Project	<b>IEEE 802.16 Broadband Wireless Access Working Group</b> < <a href="http://ieee802.org/16">http://ieee802.org/16</a> >	
Title	Some consideration on the credit token principle	
Date Submitted	<b>2006-07-10</b>	
Source(s)	Wu Xuyong, Huawei Huawei Industrial Base, Bantian, Longgang, Shenzhen 518129 P.R.C	Voice: +86-755-28972327 Fax: <a href="mailto:wuxuyong@huawei.com">wuxuyong@huawei.com</a>
Re:	80216h-06_016: Second Working Group Review: P802.16h Working Document (2006-06-05)	
Abstract	Reconsideration on the principle of credit token.	
Purpose	Consolidate the WirelessMAN-CX mechanisms.	
Notice	This document has been prepared to assist IEEE 802.16. It is offered as a basis for discussion and is not binding on the contributing individual(s) or organization(s). The material in this document is subject to change in form and content after further study. The contributor(s) reserve(s) the right to add, amend or withdraw material contained herein.

## **Some consideration on the credit token principle**

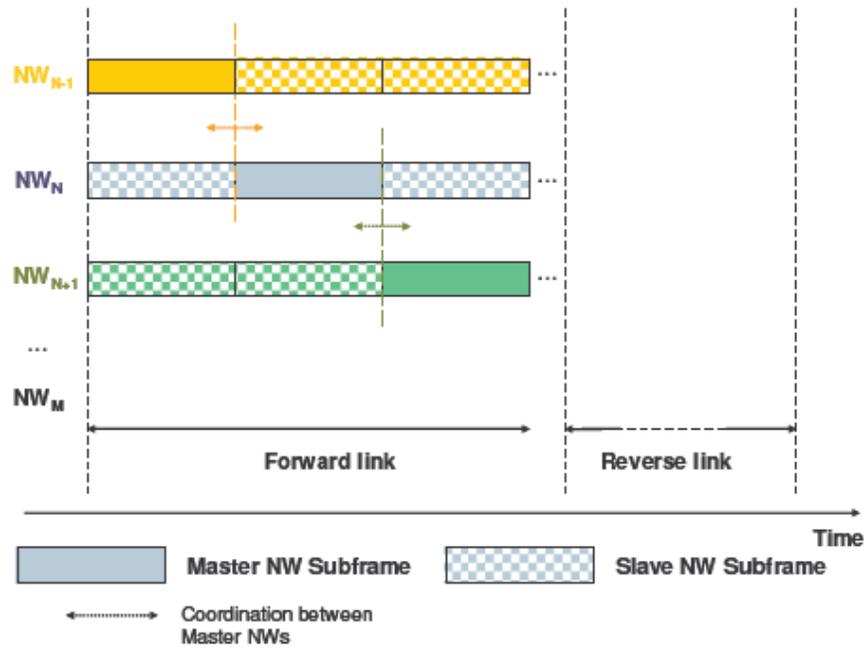
The figure above is taken from the current working document, talking about basic principle of credit token mechanism. This idea relies on the feasibility of distributed variable subframe boundary in WirelessMAN-CX system. I have shown my worry about it for a rather long time and no fundamental progress on this topic have been found yet.

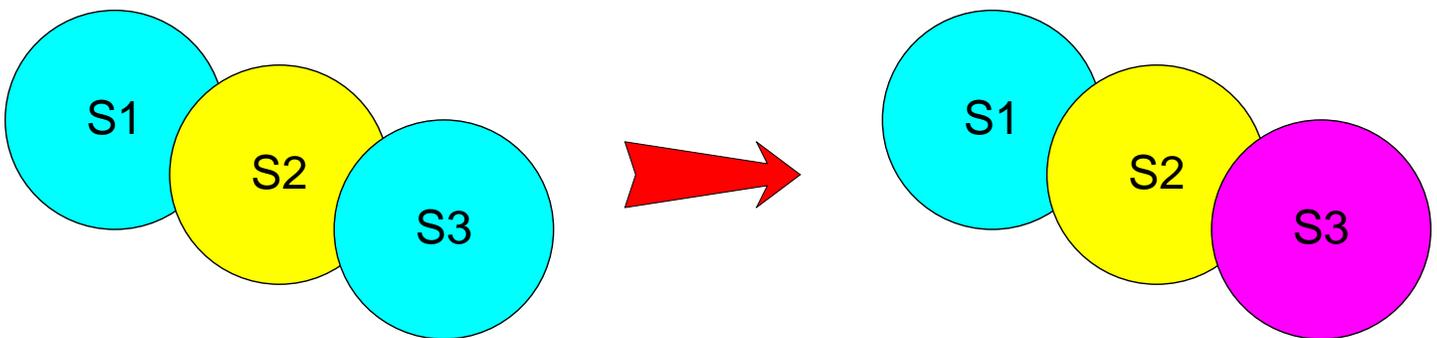
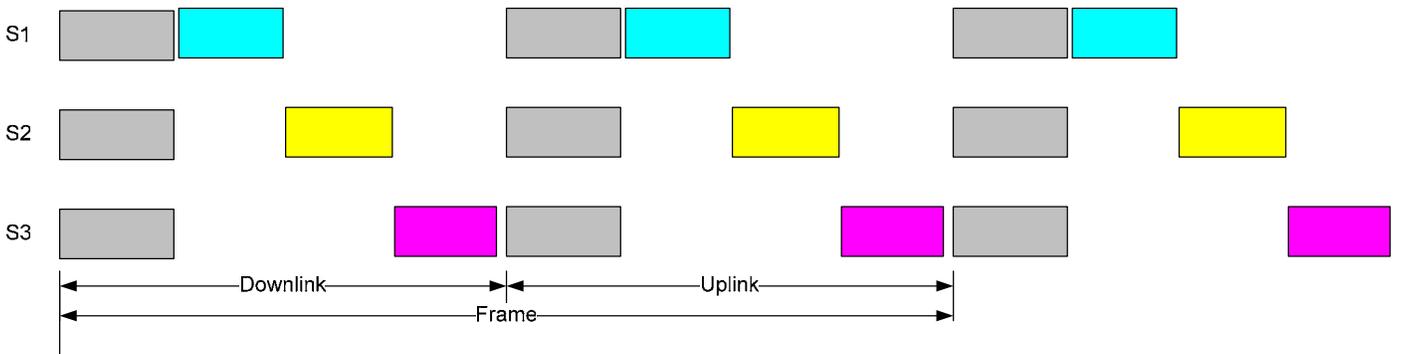
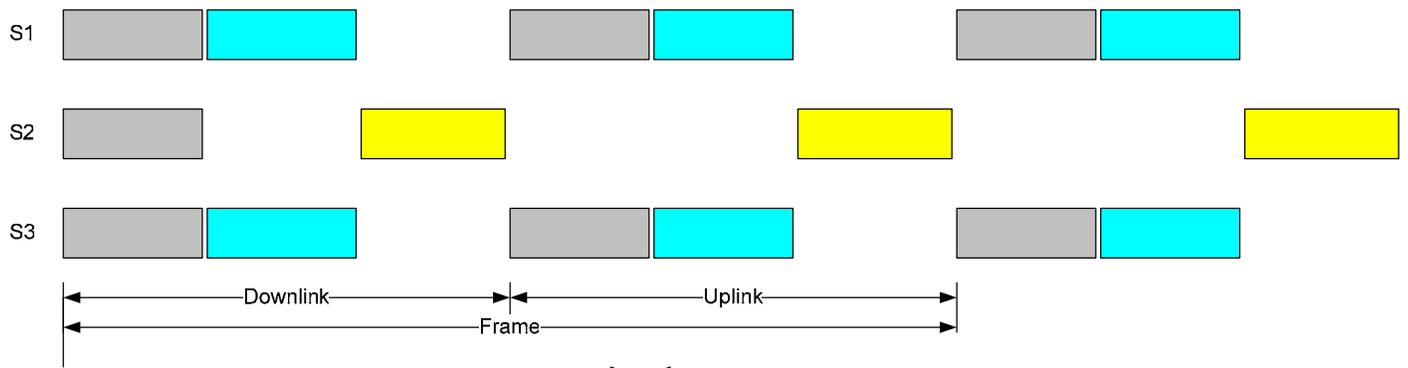
If the S1 find his downlink subframe are superfluous and about to rent it out to S2, and S2 are also want to rent in some bandwidth, they will negotiate using credit token mechanism described in current working document. And S1 may temporary successful rent out some bandwidth to S2, and the new result of frame structure become the aspect shown below:

The issue here is easily seen, the time which S2 has rent in as its extension of master subframe will cause confliction with the master subframe of S3, and obviously affect S3's benefit, neither S2 itself can make use of the time just rent in from S1.

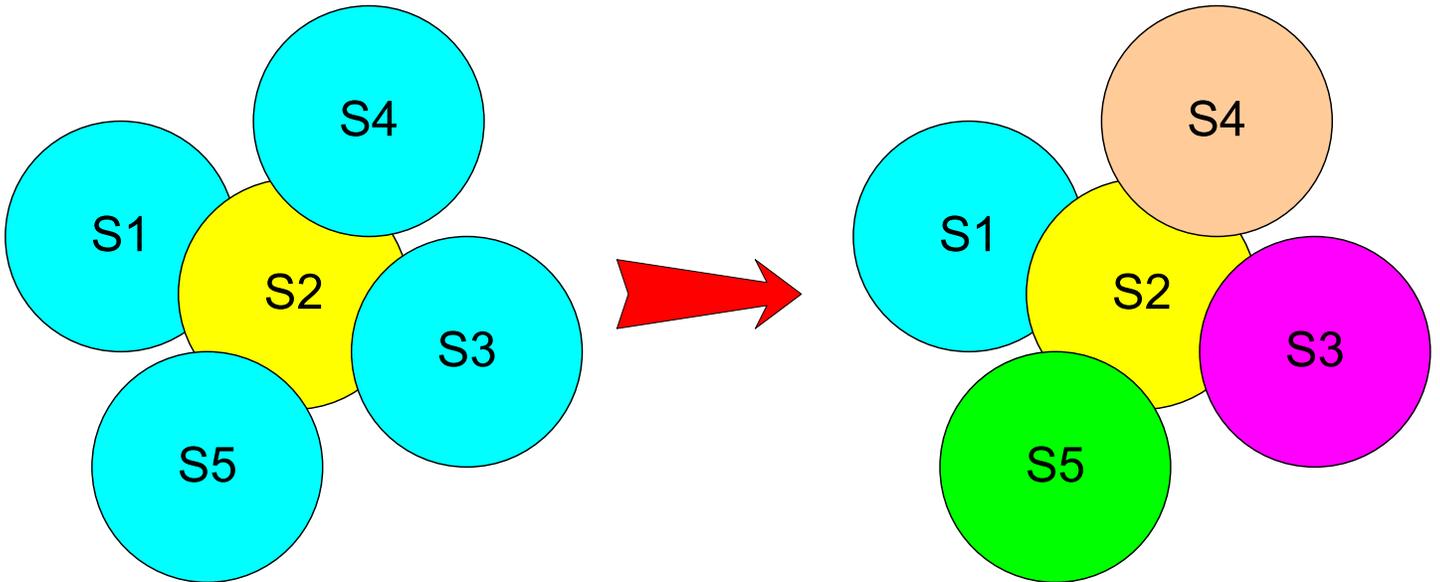
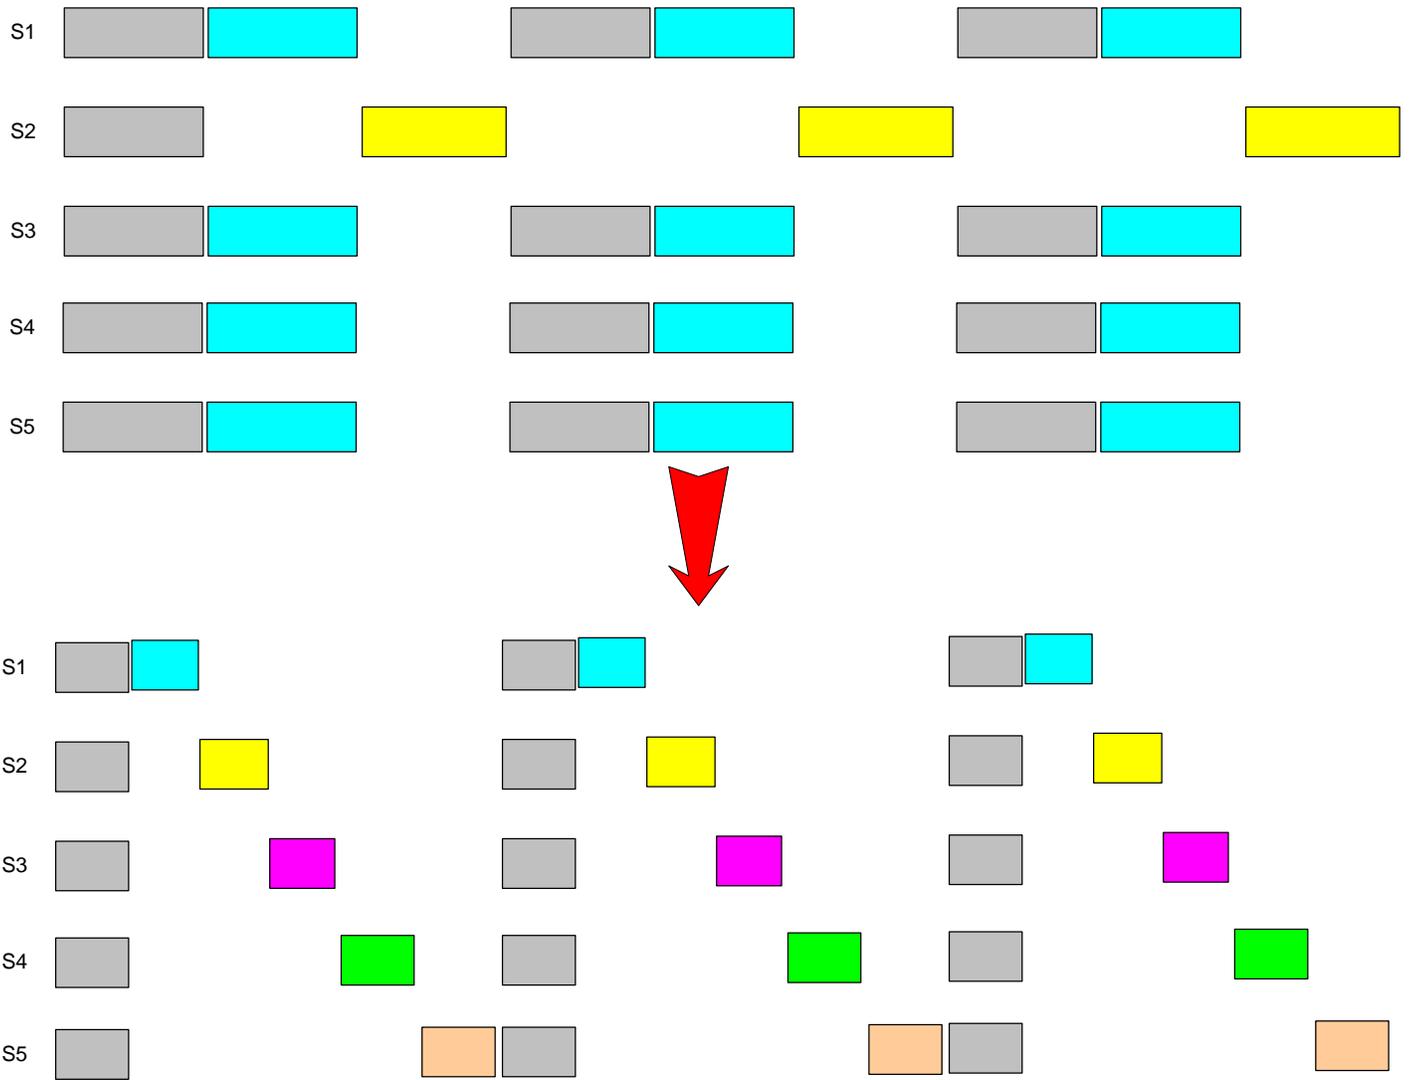
Severer case will lead to worse situation, e.g.:
